## PCN – Process Change Notification

Change:	FW.81.SMA.M
Date:	2017/08/04
Author	Haley Tsai

Model#	Part Number	Changes
135MHz Flexible Whip Antenna SMA(M) Straight	FW.81.SMA.M	<ol style="list-style-type: none"> <li>1. Amend <math>\varnothing 4 \pm 0.3\text{mm}</math> to <math>3.7 \pm 0.2\text{mm}</math>.</li> <li>2. Amend <math>\varnothing 61 \pm 0.3\text{mm}</math> to <math>\varnothing 61 \pm 0.5\text{mm}</math>.</li> <li>3. Amend <math>\varnothing 16.05 \pm 0.2\text{mm}</math> to <math>\varnothing 16 \pm 0.5\text{mm}</math>.</li> <li>4. Amend cap material from ABS to POM.</li> </ol>

## Illustration of Change

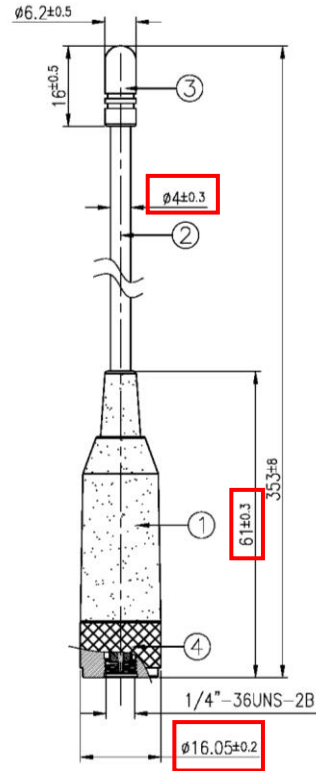
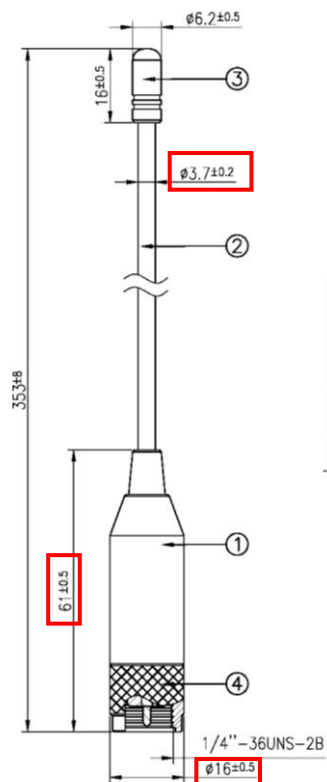
1. Amend  $\varnothing 4 \pm 0.3\text{mm}$  to  $3.7 \pm 0.2\text{mm}$ .
2. Amend  $\varnothing 61 \pm 0.3\text{mm}$  to  $\varnothing 61 \pm 0.5\text{mm}$ .
3. Amend  $\varnothing 16.05 \pm 0.2\text{mm}$  to  $\varnothing 16 \pm 0.5\text{mm}$ .
4. Amend cap material from ABS to POM.
